Addendum No. 2
March 20, 2026

Project: Union County Courthouse Addition and Renovation
Elk Point, South Dakota
Architecture Incorporated Project Number 0728.2893.20

Architect: Architecture Incorporated

UNION COUNTY COURTHOUSE ADDITION AND RENOVATION
BASEMENT REFLECTED CEILING PLAN

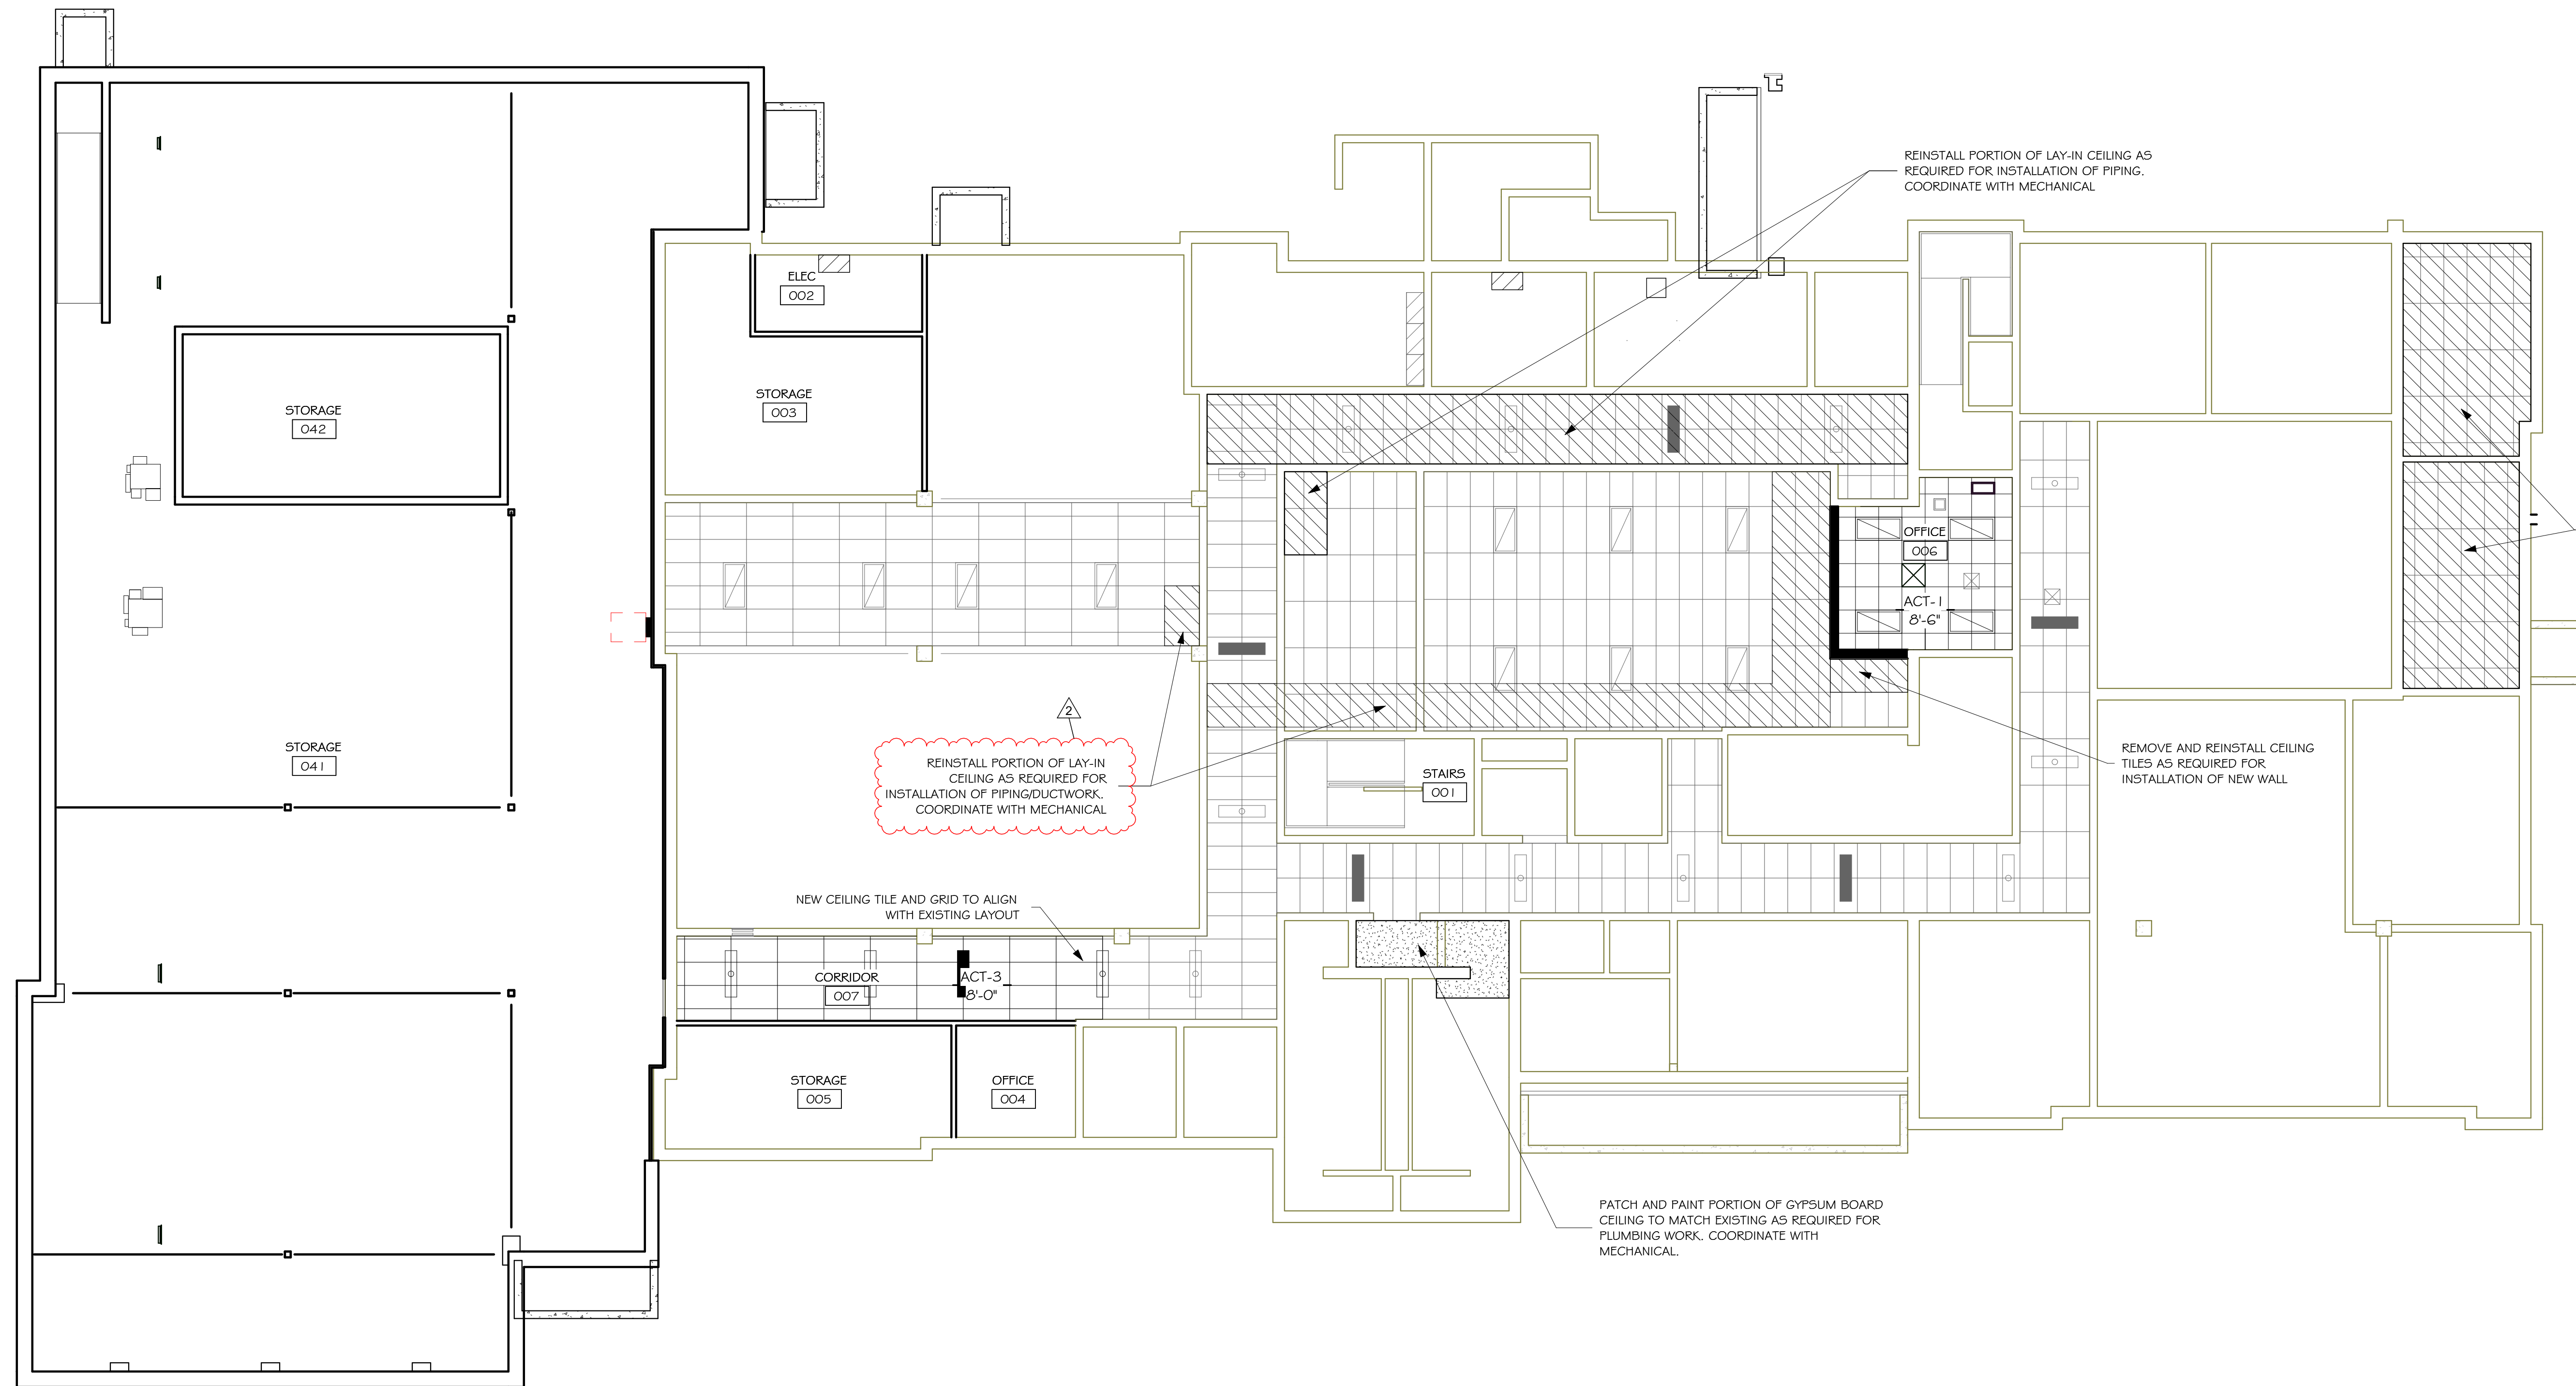
9. DRAWING SHEET 6.10 – BASEMENT REFLECTED CEILING PLAN
 - a. See attached revised Drawing Sheet 6.10, revising extents of existing ceiling removal and reinstallation

19 JAIL ADMIN COUNTER
SCALE: 1" = 1'-0"

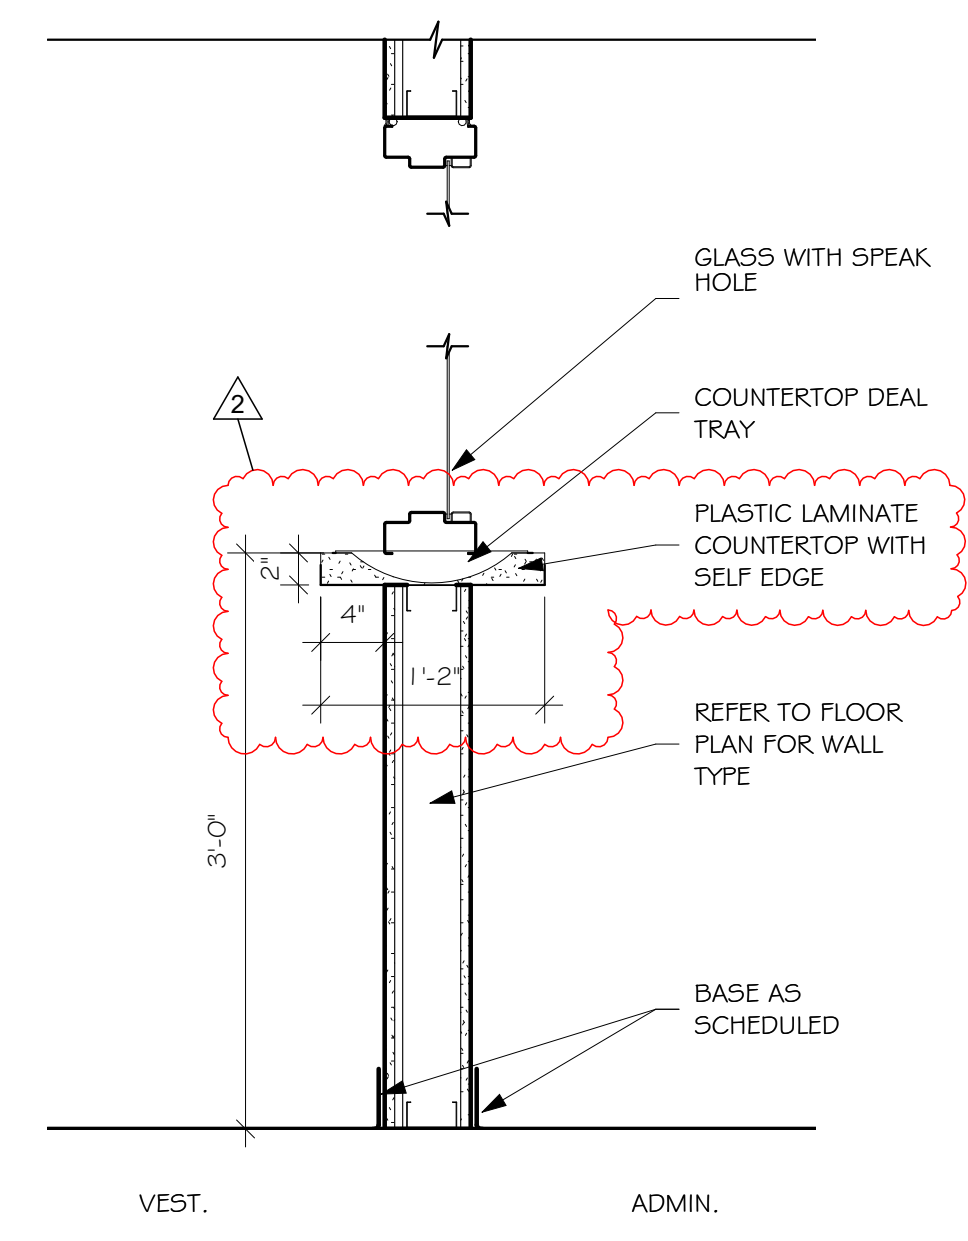
- a. See attached revised Drawing 7.20, revising countertop edge profile at Jail Admin Counter (19/7.20) to a square self-edge.

UNION COUNTY COURTHOUSE ADDITION AND
 RENOVATION
 BASEMENT FLOOR PLAN - TEMPERATURE CONTROL ALTERNATE

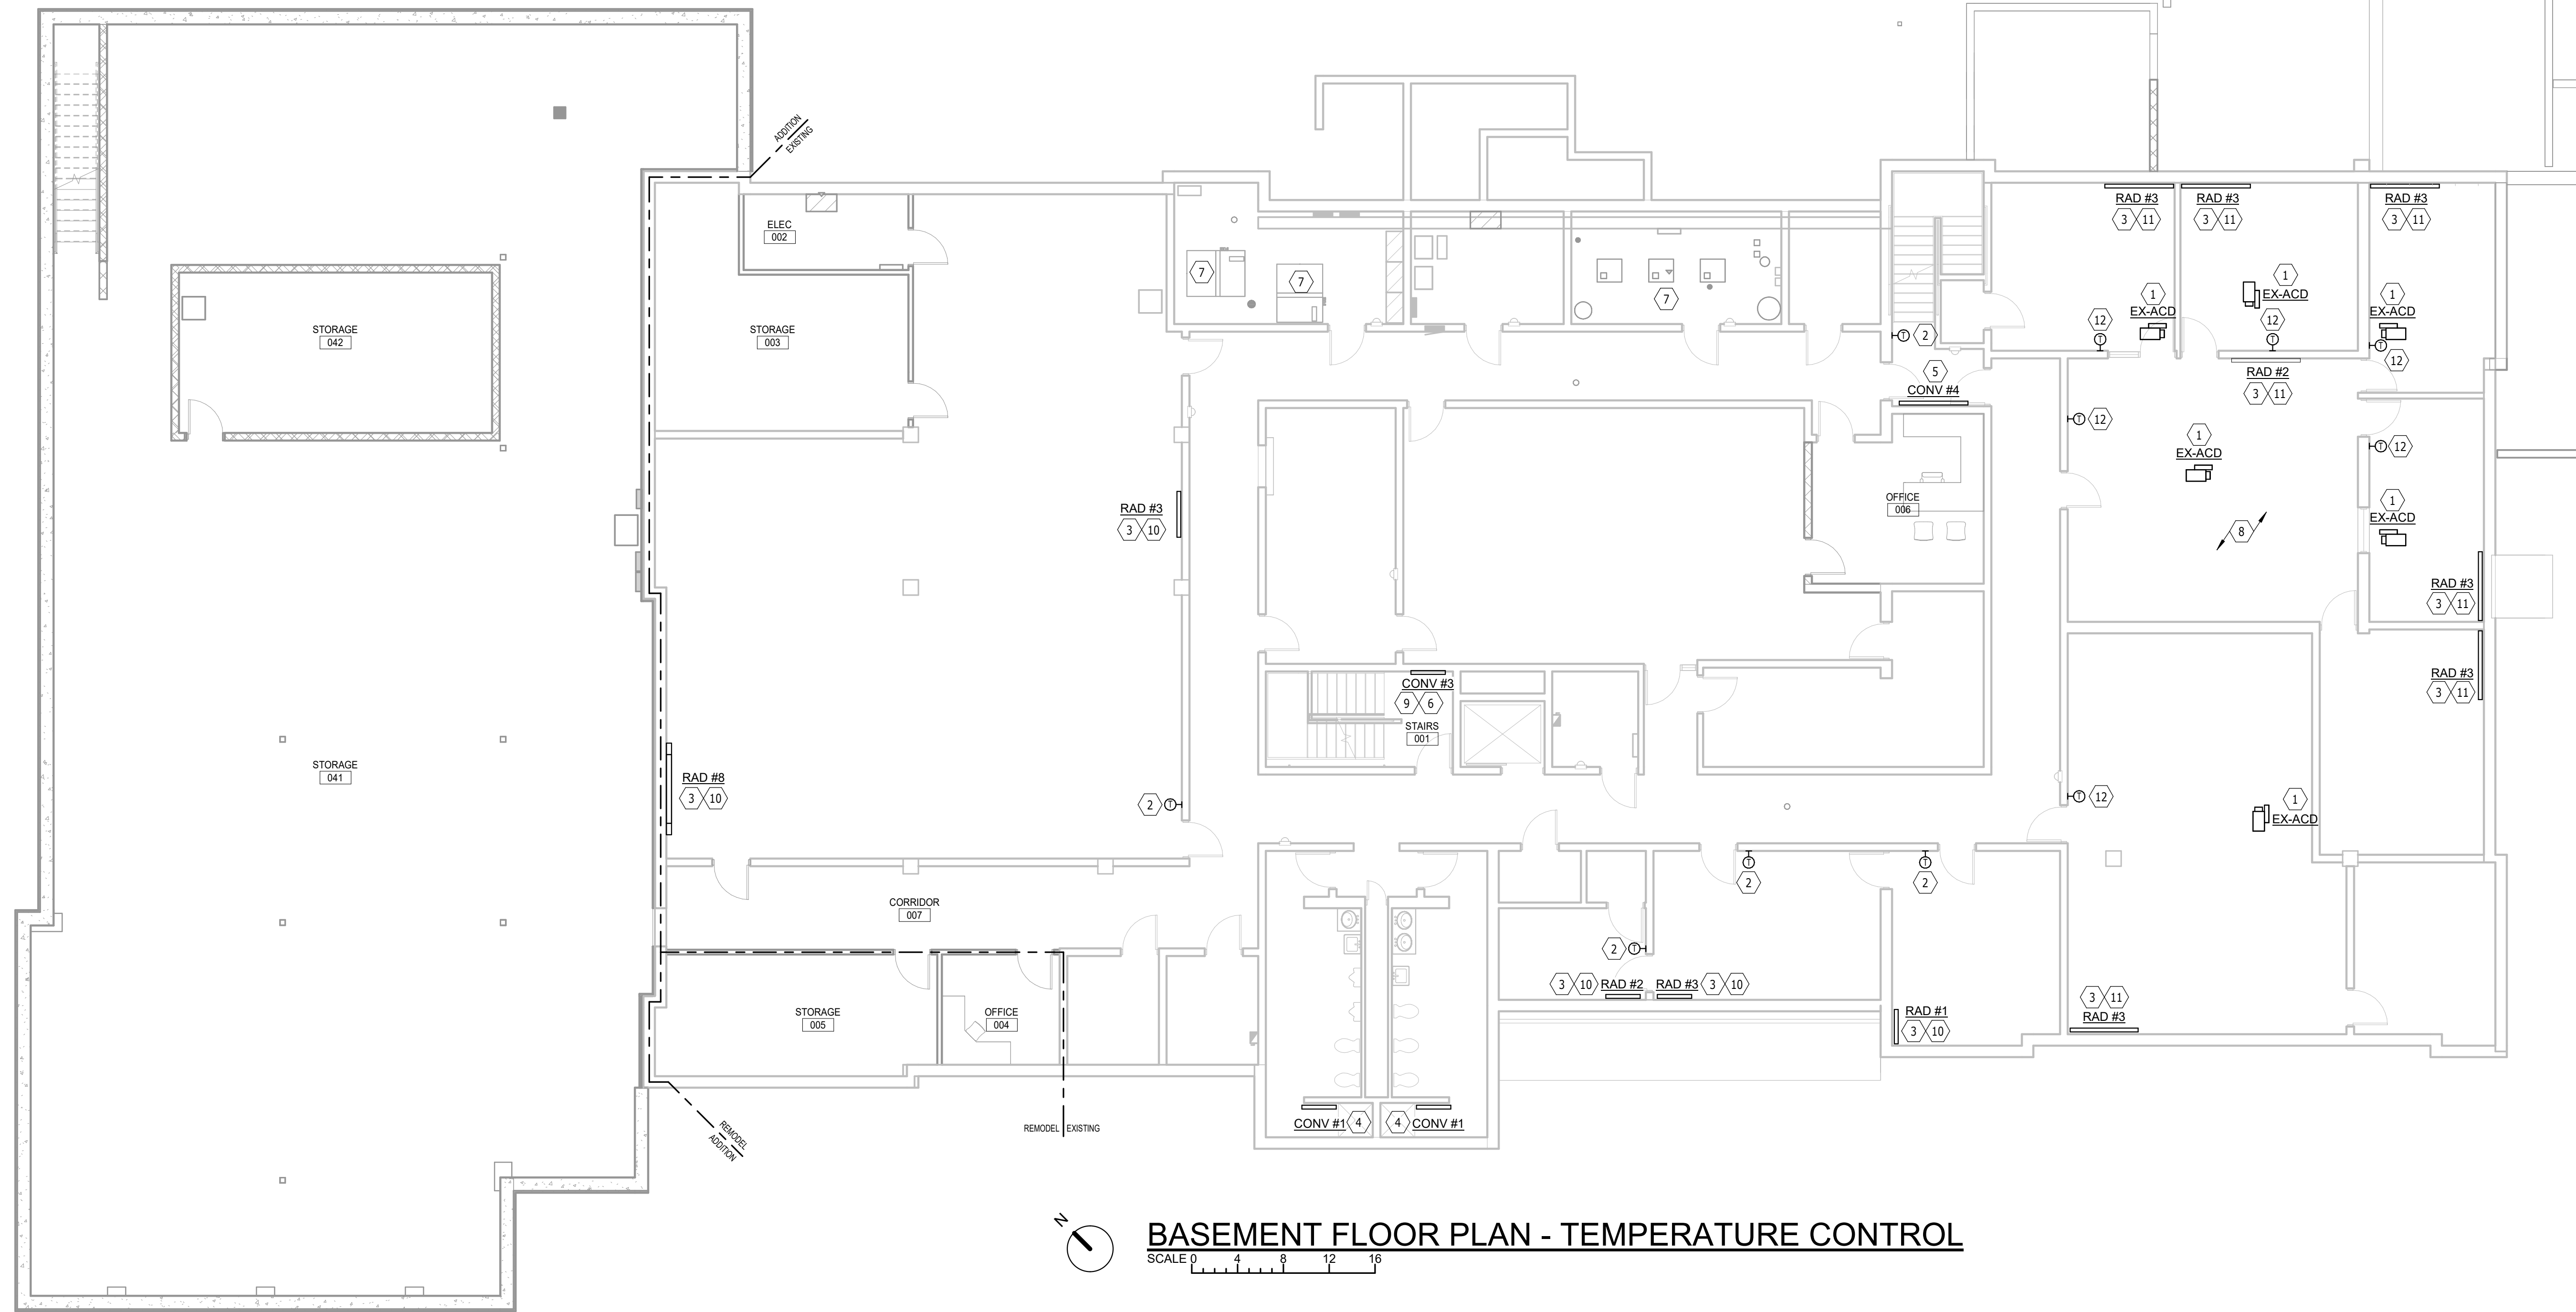
- a. See revised drawing sheet 8.42, incorporating the added temperature control layout and design.
